M	VP Vari	ance Re	equest	Form	Varia	ance Request		
NA MAG	untain			Date An	nroval P	eguested	<b>No.:</b> by Contractor:	E-4 4/10/2018	
VIOI	untain Valley				•	•	•	4/10/2010	
	PIPELINE Luc	Date Submitted by Chief Inspector to LEI:  Date Received by FERC:							
	ſ		FEF	C Appro		ence No.:	,		
					_	_	Variance	1440	
Requested By:	Andy Travenio			Sp	oread:	E Varia	Type: ince Sequence	WS	
Request Prepared By *:	Megan Neylon					Varie	Number:	004

MVP PIPELINE PROJECT - H600 LINE RALEIGH CO., WEST VIRGINIA

## Mountain Valley Pipeline Project Variance E-4 April 12, 2018

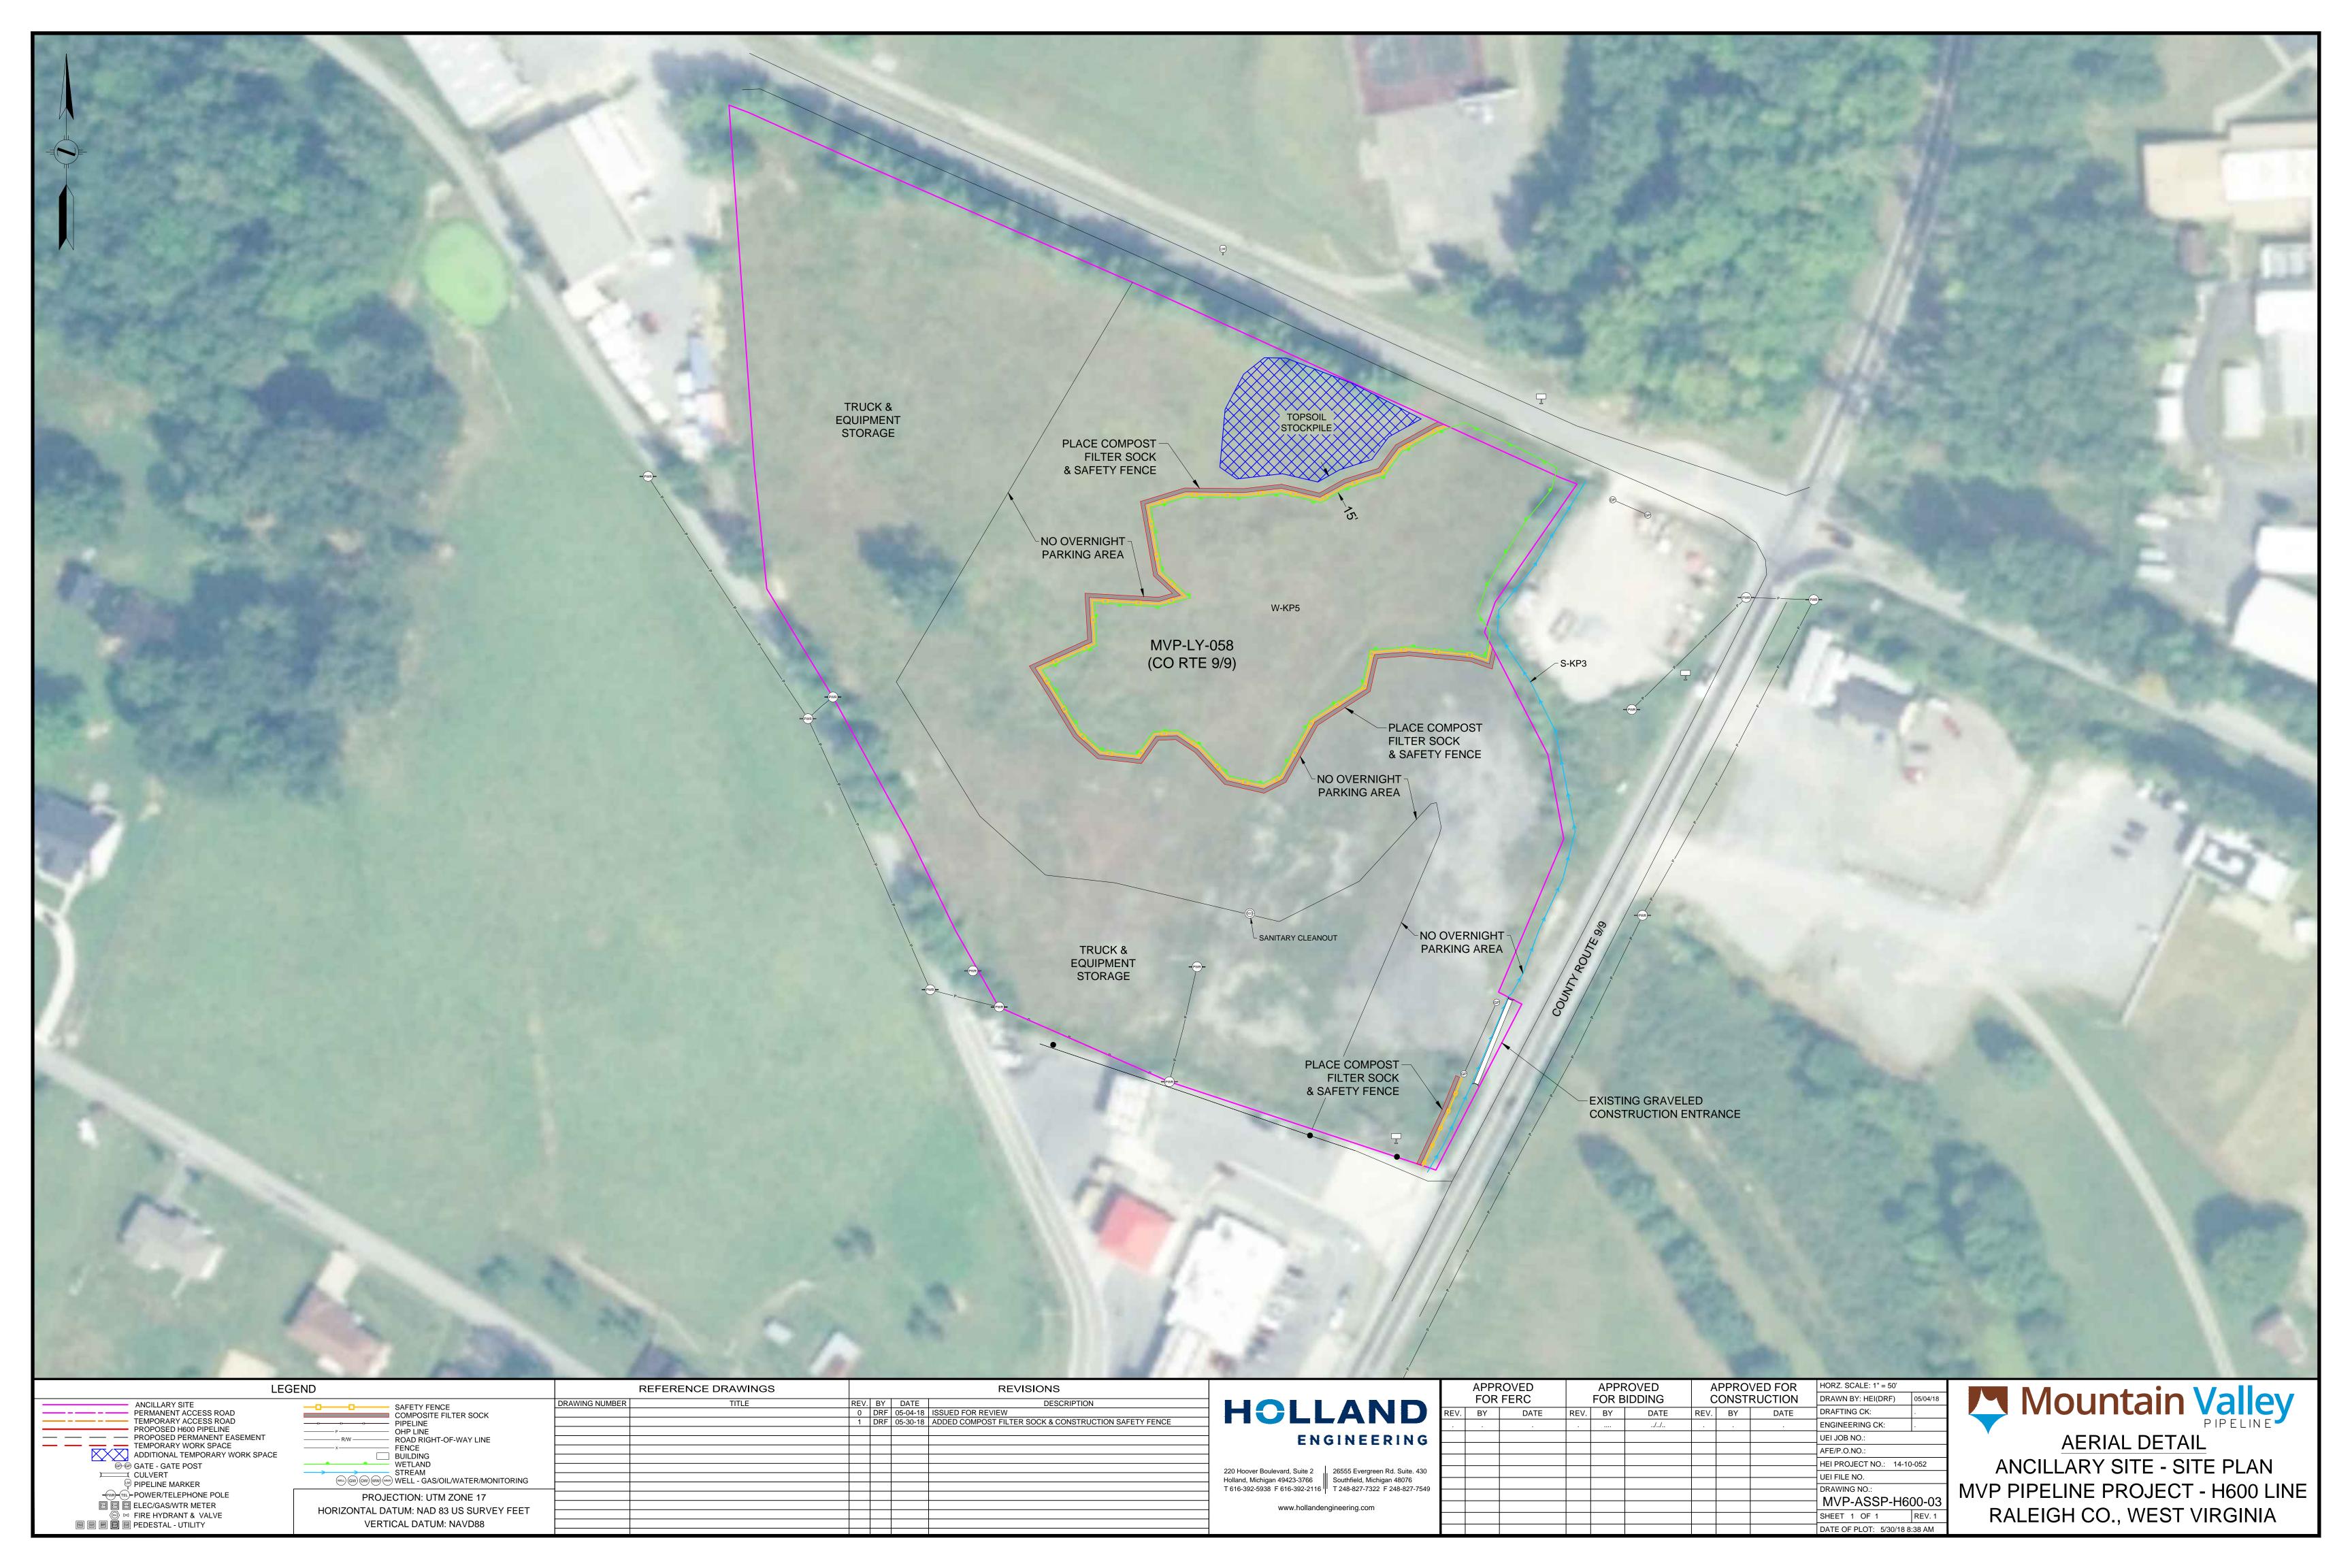
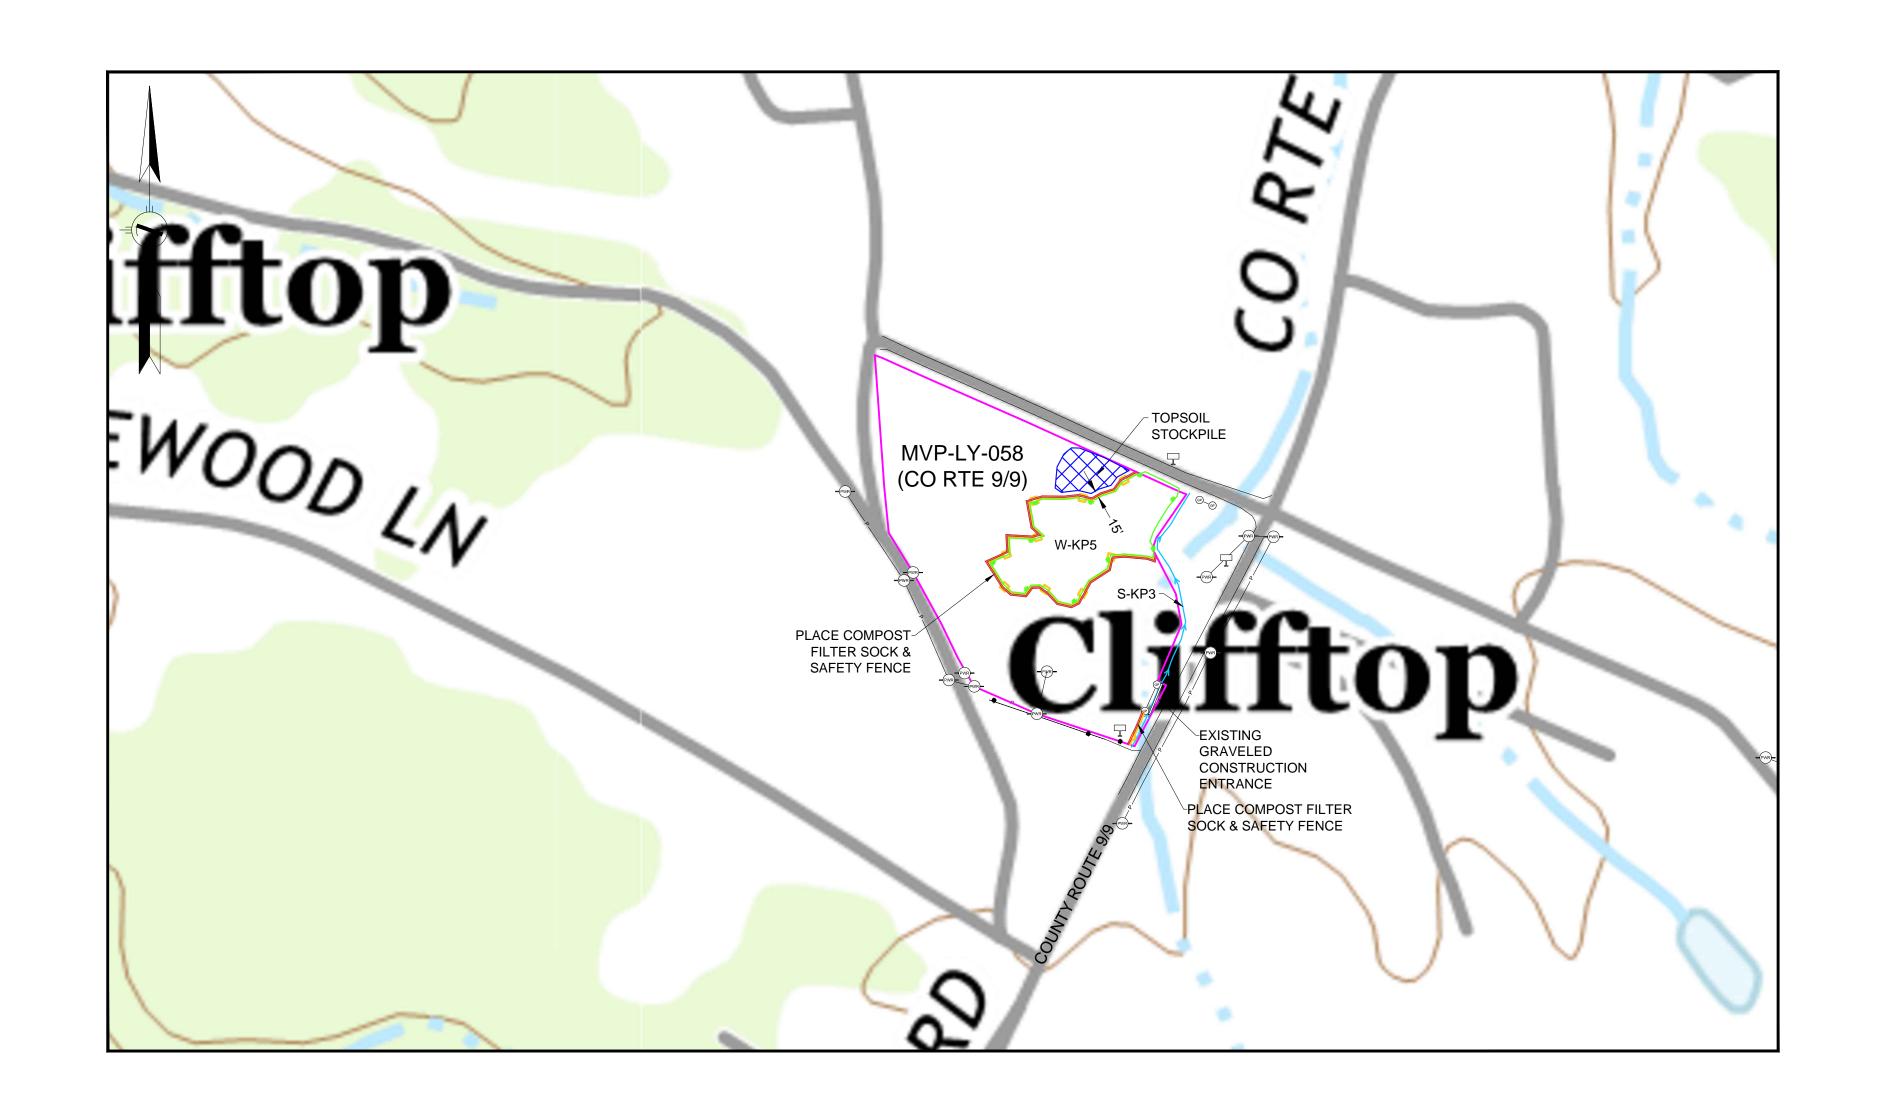
Tree Clearing Required:  Variance Level:  Variance From:  Detailed Description of Added laydown yard MVP-LY- wetland impact, travel through truck travel and parking. Trees Project plans, BMPs will be installed	Yes  Level 1  Permit Plan  Line List  Variance:  058. Laydown yard not the yard will be restricted to minimize impacts to the variance to avoid impacts to the permeter of the	Attachmer ecessary for coted. It is nece of the yard with pacts to any e	clear  Level 3  res	Yes [agging. This rece. Resources ensitive and idition, imparts.]	Specificat Other: De No yard will be trees locate ces have b eas within/ acts to stree	Photo used mainly do in the mideen avoided abutting the am S-KP3 w	os?  y to stage pipe str dle of the yard so to the extent prac area. Wetland W- ill be avoided by u	Yes  No inging trucks. Due to as to not interfere with ticable. Per approved KP5 is located within tilizing an existing

LEG	REF	ERENCE DRAWINGS					
ANCILLARY SITE PERMANENT ACCESS ROAD TEMPORARY ACCESS ROAD PROPOSED H600 PIPELINE PROPOSED PERMANENT EASEMENT TEMPORARY WORK SPACE ADDITIONAL TEMPORARY WORK SPACE  GO GATE - GATE POST CULVERT PIPELINE MARKER POWER/TELEPHONE POLE EM ELEC/GAS/WTR METER FIRE HYDRANT & VALVE PEDESTAL - UTILITY	SAFETY FENCE COMPOSITE FILTER SOCK PIPELINE OHP LINE ROAD RIGHT-OF-WAY LINE FENCE BUILDING WETLAND STREAM WETLAND STREAM WELL - GAS/OIL/WATER/MONITORING  PROJECTION: UTM ZONE 17 HORIZONTAL DATUM: NAD 83 US SURVEY FEET VERTICAL DATUM: NAVD88	DRAWING NUMBER	TITLE	0	DRF	DATE DESCRIPTION  05-04-18 ISSUED FOR VARIANCE  05-30-18 ADDED COMPOST FILTER SOCK & CONSTRUCTION SAFETY FENCE	220 Hoover E Holland, Mich T 616-392-59
